**GEARY ELEMENTARY / MIDDLE SCHOOL
PAVEMENT REPAIR AND IMPROVEMENTS**

ADDENDUM #2

JUNE 2, 2021

THRASHER PROJECT #060-0989

THRASHER
 THE THRASHER GROUP, INC.
 300 ASSOCIATION DRIVE
 CHARLESTON, WV 25311
 PHONE (304) 343-7601

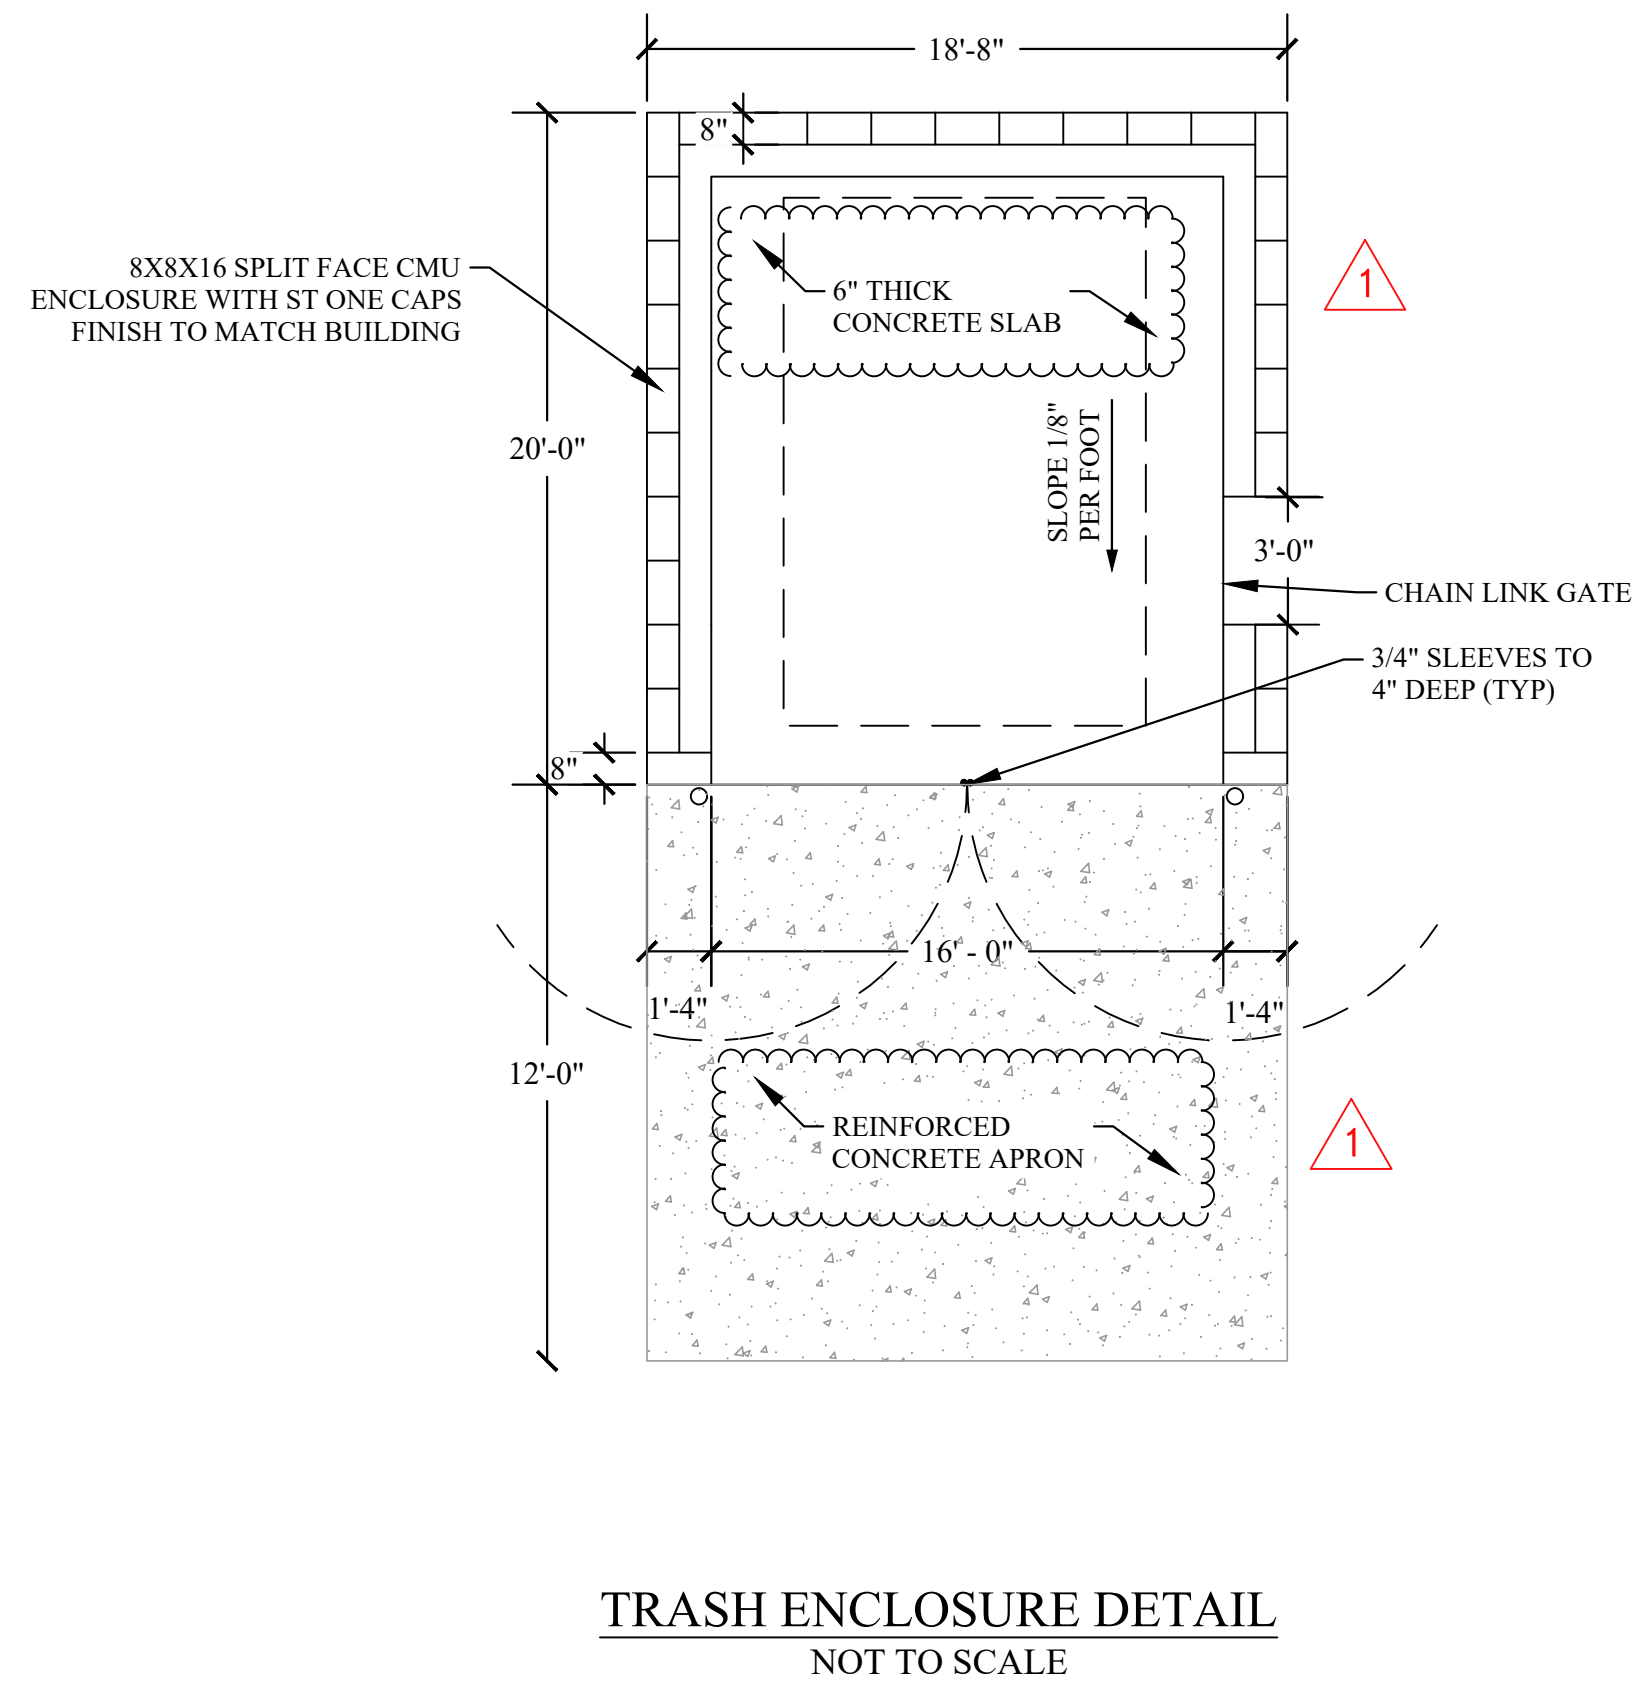
NO.	BY	DATE	DESCRIPTION
1	CLM	06/01/21	ADDED CONCRETE APRON AND SLAB SECTION DETAILS.

C2.03R1

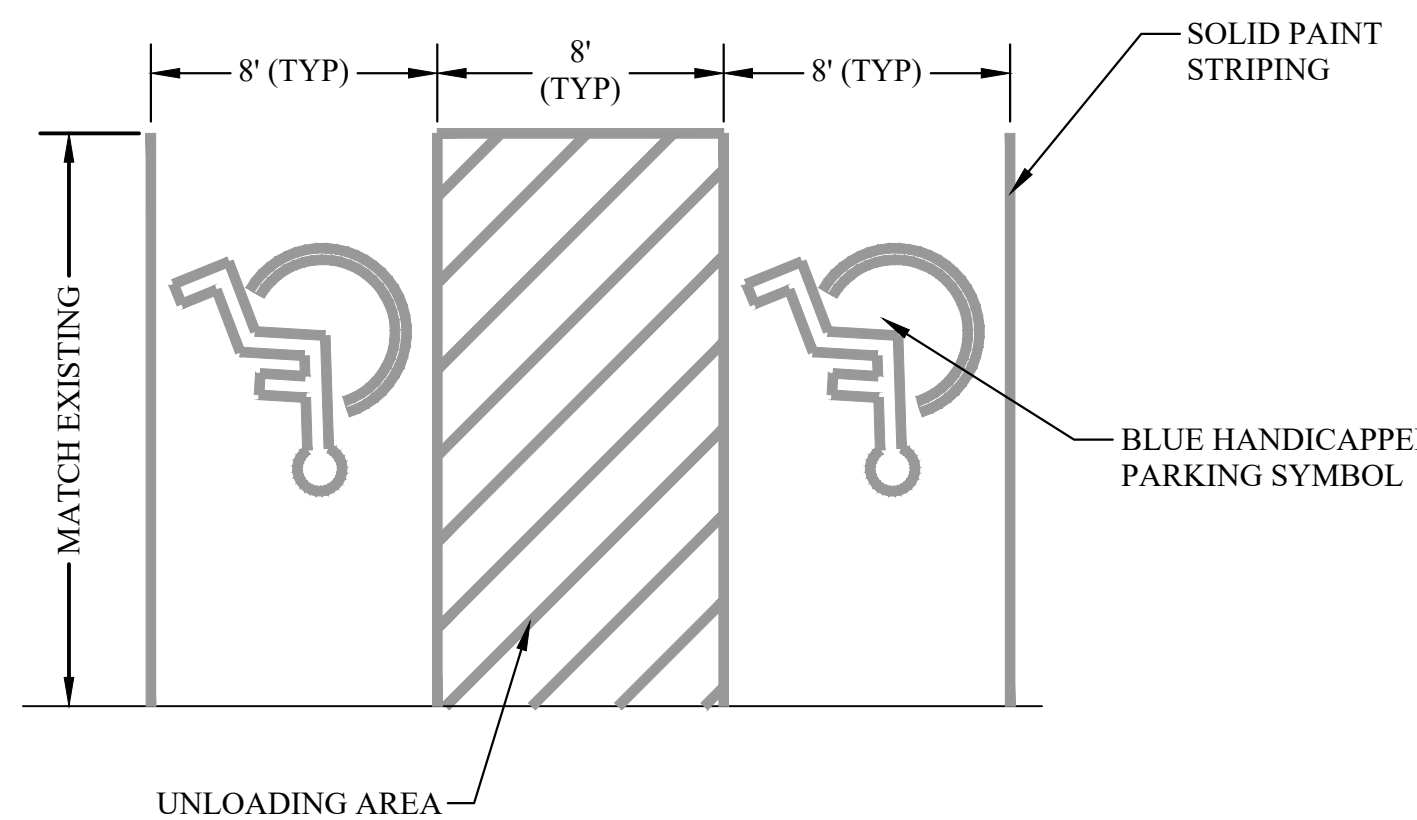
3. **Comment:** Will the Trash Enclosure need to have concrete footers.

NO.	BY	DATE	DESCRIPTION
1	CLM	06/01/21	ADDED CONCRETE SLAB AND APRON TO TRASH ENCLOSURE.

Response: The proposed trash enclosure will need concrete footers. Instead, the enclosure shall be placed on a concrete slab per the revised detail provided on Sheet C2.03 of the plan set.
